रेल कोच फैक्ट्री, कपूरथला
RAIL COACH FACTORY, KAPURTHALA

दस्तावेज स.: शुद्धिपत्र-10
Document No.: Corrigendum-10

This Corrigendum is issued to specification for Wheel Set Earthing Device i.e. EDTS-101, Rev-C, Am-3, Corr-9, with Annexure-1 wherein the design of spring for Cover of WSEE have been modified and accordingly following clause has been changed:

ITEM	STEEL SPRING	I	NIL	IS: 4454-2005	SPRING STEEL	NIL
GROUP	ELECTRICAL	SPARELY	DETAIL	DRS	MATL. & SPEC.	REMARKS
FILE	D:\BKR\MEDTS\eds101lw71250b.dpt (3D)				LW71250 ALT 2	
SCALE					1:1	
DATE					19/05/2009	
PL NO.					NIL	
DRG. NO.					LW71250	
ALT. 16					BY 05/05/09	
BY 05/05/09

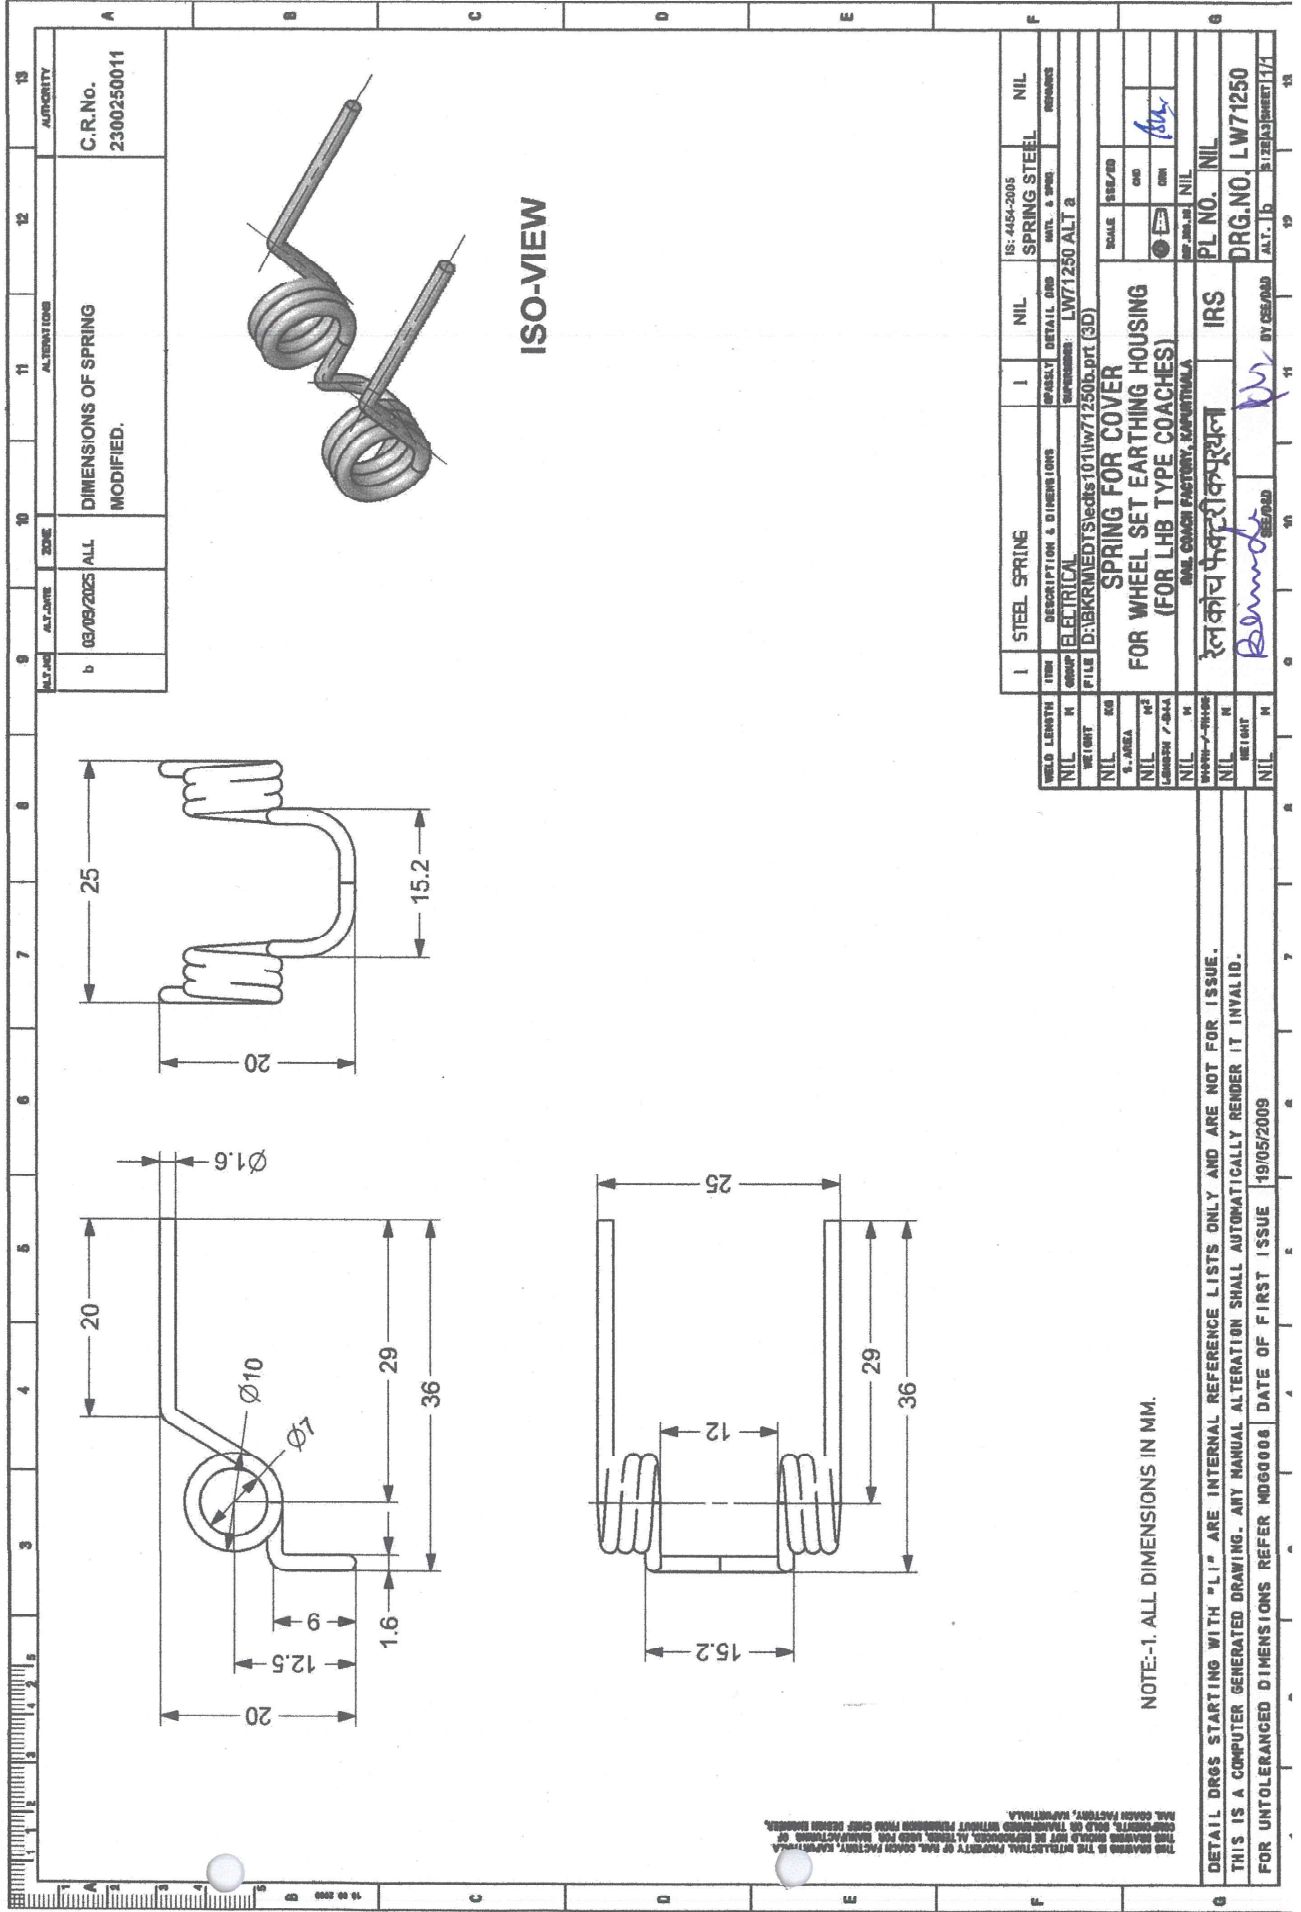
ALT. DATE	ZONE	ALTERATIONS	AUTHORITY
b	03/05/2005	ALL	
		DIMENSIONS OF SPRING MODIFIED.	C.R.No. 2300250011

S.No.	Existing drg. no.	Revised drg. no.
xxi	Drg. no. LW71250 alt.-'a'	Drg. no. LW71250 alt.-'b'
